March 3, 2014

RE: Capisic Pond Enhancement, Level III Site Plan Application, Response to Comments

VIEW 1
 SCALE: H 1"=30'
 V 1"=15'

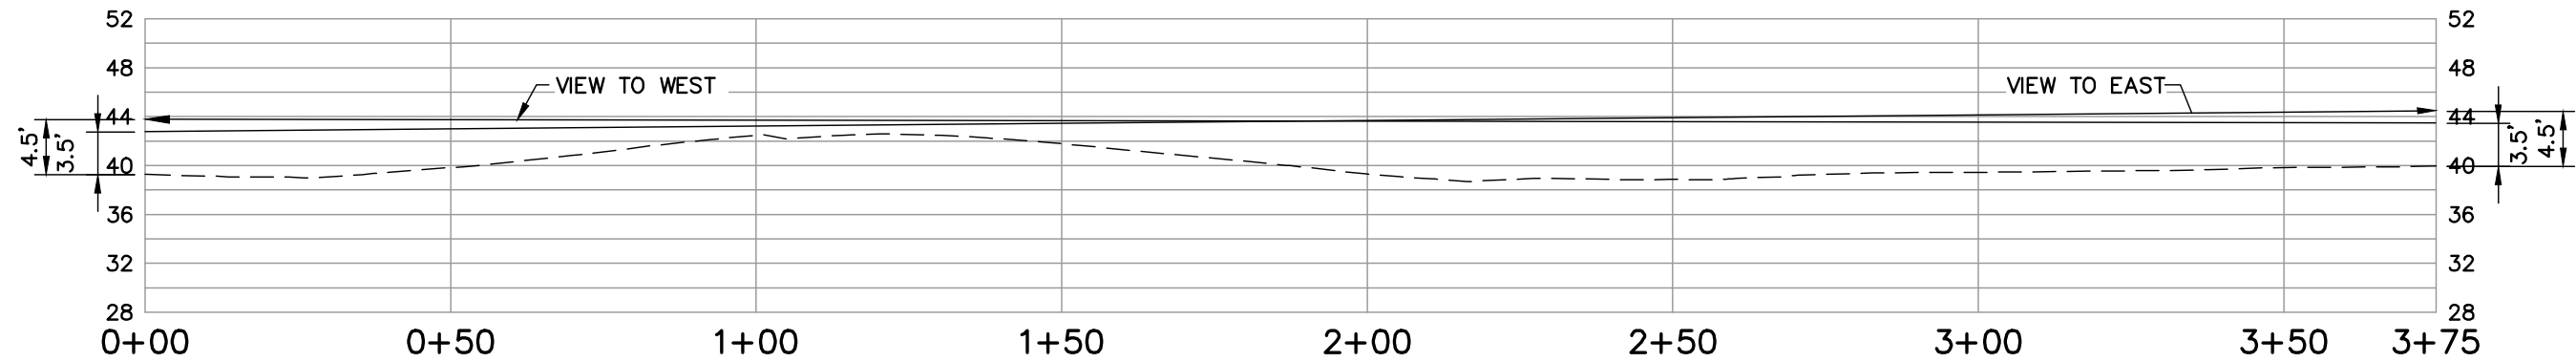
2. *Sight distance measurements shall be provided for proposed temporary driveways with discussion on meeting City standards.*

View 1 on the attached figures represents the view to the east from a vehicle in the temporary access drive. This is also the view path for a vehicle in the west-bound lane of Capisic Street to view a vehicle in the temporary access drive. Utilizing the DOT recommended heights for sight distance analysis, a clear line of sight will be available in both directions. A review of tree locations indicates that trees on the Capisic property will not block sight distance.
